Project	<b>IEEE 802.16 Broadband Wireless Access Working Group</b> < <a href="http://ieee802.org/16">http://ieee802.org/16</a> >	
Title	<b>Obtaining Sleep Mode Information in RS</b>	
Date Submitted	<b>2006-11-15</b>	
Source(s)	<p>Yuefeng Zhou; Mike Hart; Sunil Vadgama Fujitsu Laboratories of Europe Ltd Hayes Park Central, Hayes End Road, Hayes, Middlesex, UB4 8FE, UK</p> <p>Shiao-Li Tsao, Fang-Ching Ren, Wern-Ho Sheen, I-Kang Fu National Chiao Tung University (NCTU) /Industrial Technology Research Institute (ITRI), Taiwan No. 195, Sec. 4, Chung Hsing Rd., Chutung, Hsinchu, Taiwan 310, R.O.C.</p>	<p>Voice: +44 (0) 20 8573 4444 FAX: +44 (0) 20 8606 4539 <a href="mailto:yuefeng.zhou@uk.fujitsu.com">yuefeng.zhou@uk.fujitsu.com</a> <a href="mailto:mike.hart@uk.fujitsu.com">mike.hart@uk.fujitsu.com</a> <a href="mailto:sunil.vadgama@uk.fujitsu.com">sunil.vadgama@uk.fujitsu.com</a></p> <p>Voice: +886-3-5712121-54717 Fax: +886-3-5721490 E-mail: <a href="mailto:sltsao@cs.nctu.edu.tw">sltsao@cs.nctu.edu.tw</a>;<a href="mailto:frank_ren@itri.org.tw">frank_ren@itri.org.tw</a></p>

# Obtaining Sleep Mode Information in RS

Fig. 1. RS decodes the MOB\_SLP\_RSP message for further scheduling

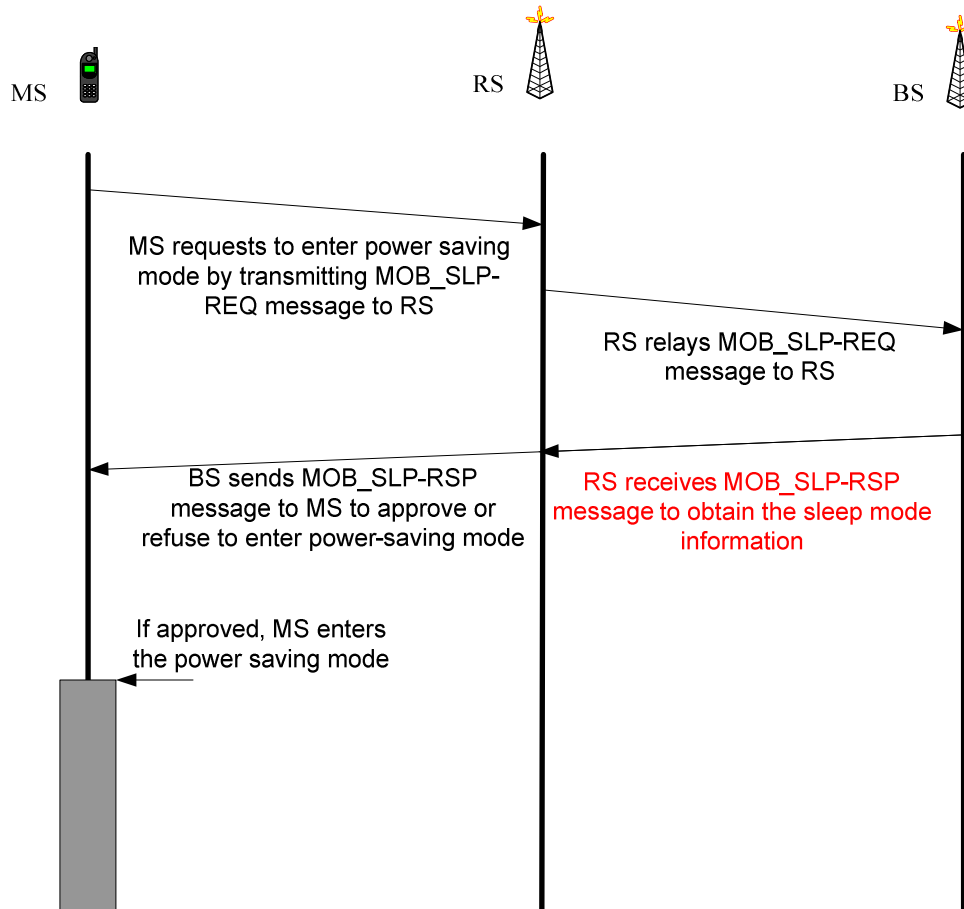
RS may have the capability to listen and decode the MOB\_SLP\_RSP message to obtain the sleep-mode information. For example, if the sleep mode is initialized by MS, as shown in Fig. 1, RS shall decode the MOB\_SLP\_RSP message sent by MR-BS to obtain enough timing information, thus it can allocate resources to MS on time for the event-based actions, also RS can avoid sending management messages to this MS, and can cancel the bandwidth allocated to MS during the sleep period.
